VALIDATION REPORT for the Project Activity

Unyte Biochar

Report No: CCIPL2313/RIVERSE/VAL/UNBR/20240604

Report Date: 03-09-2024

Figure 1: Detailed depiction of the system boundary

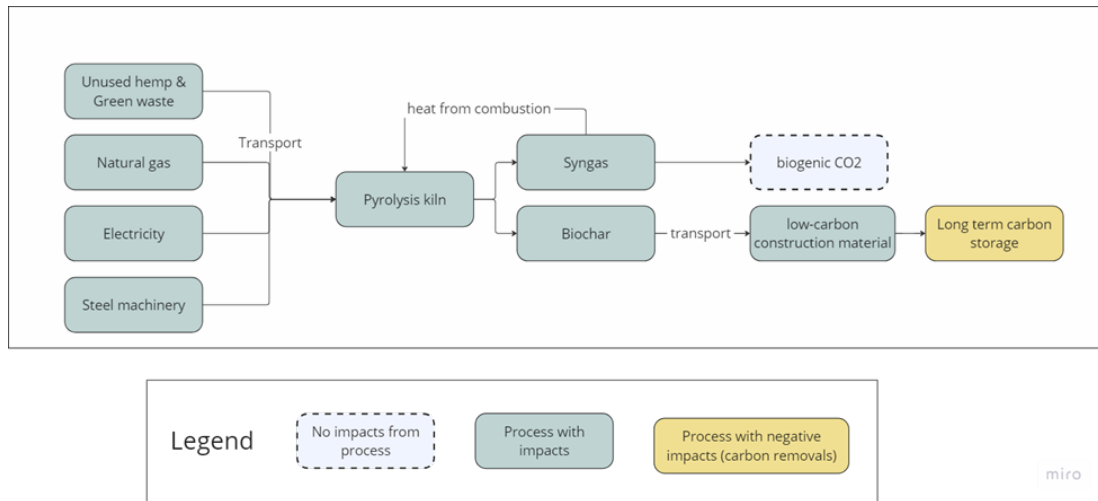
In summary, the project boundary was correctly identified in accordance with the methodology BECCS and Biochar (version 1.0)^{B02/}. All greenhouse gas emissions occurring within the proposed project activity boundary as a result of the implementation of the proposed offset project activity have been appropriately addressed in the offset project activity. The validation team confirms that all main GHG emission sources, the physical delineation of the project activity and other relevant project and baseline emission sources covered in the methodology are included in the system boundary.
